Office Action Summary

10/508,920

YUN-KI, BAE

FIG. 5

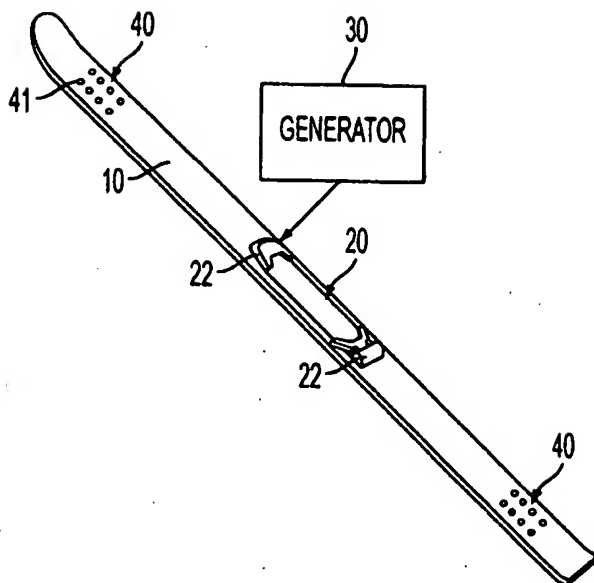
3. The proposed drawing correction, filed Dec. 22, 2006 has not been approved. The proposed new figure 5 includes what is asserted to be a binding plate as well as bindings. The provision of a binding plate separate from the bindings is not supported by the original specification and drawings as filed.

NOT
APPROVED
FBV
2/8/07

Exemplary Drawing

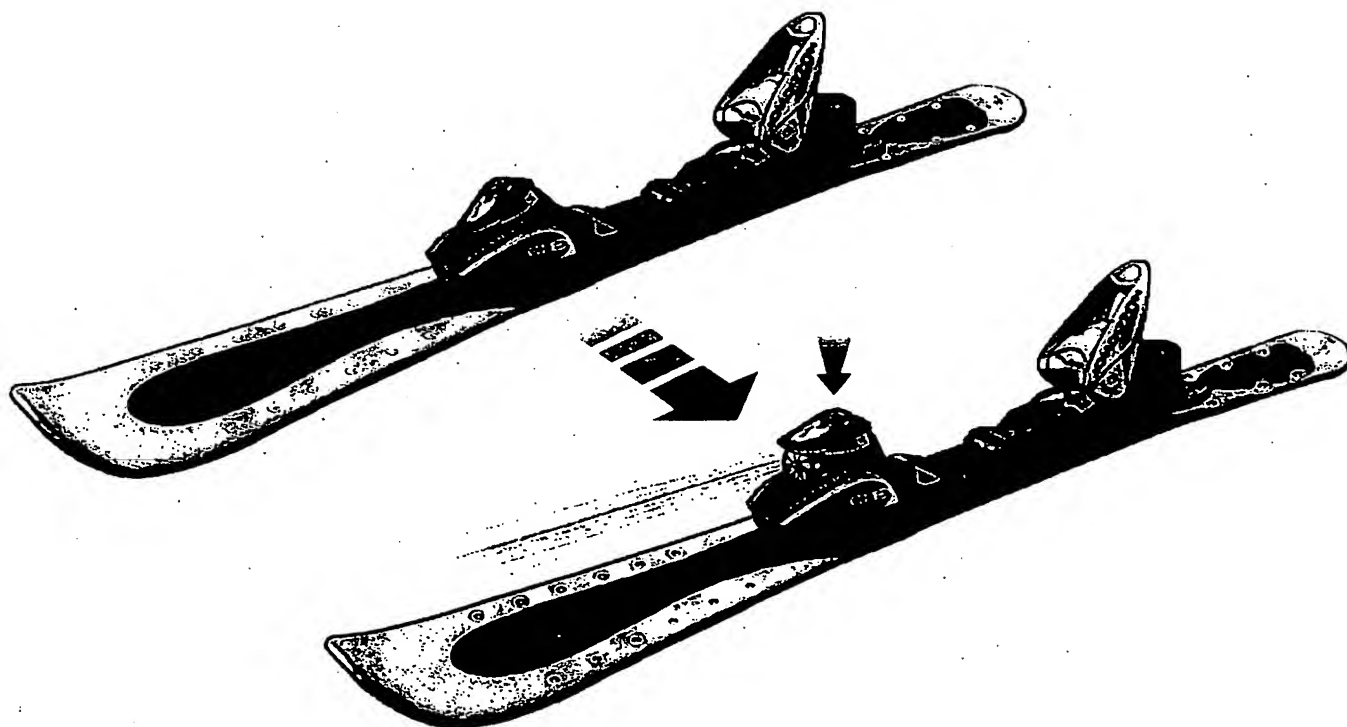
provided. Applicant's comments concerning the exemplary drawing are noted but are not persuasive. Firstly, these comments are based on material that was not present in the application as filed, and as such, material which does not constitute a part of the specification. Note that 35 USC 112, first paragraph requires that: "The specification shall contain a written description of the invention, and of the manner and process of making and using it, in such full, clear, concise, and exact terms as to enable any person skilled in the art to which it pertains, or with which it is most nearly connected, to make and use the same, and shall set forth the best mode contemplated by the inventor of carrying out his invention."

Secondly, the comments filed in association with the exemplary drawing (page 10 of the amendment papers) appear to be speculation, e.g., the binding which can somehow be opened or closed to allow exposing of the rotation wing; and are not actually based on the disclosure as filed. Applicant has not pointed to a binding structure, as disclosed in the application, that can allow such possible opening or closing, nor has applicant pointed to a binding structure as disclosed in the application, that can accommodate a rotary permanent magnet and induction coils assembly therein. If the application as filed is asserted to support the claims as currently written, then it is not clear why applicant relies on (1) "exemplary" drawings which were not part of the application as filed or (2) a speculative description which was also not part of the application as filed.

NOT PART OF
APPLICATION
DRAWINGS
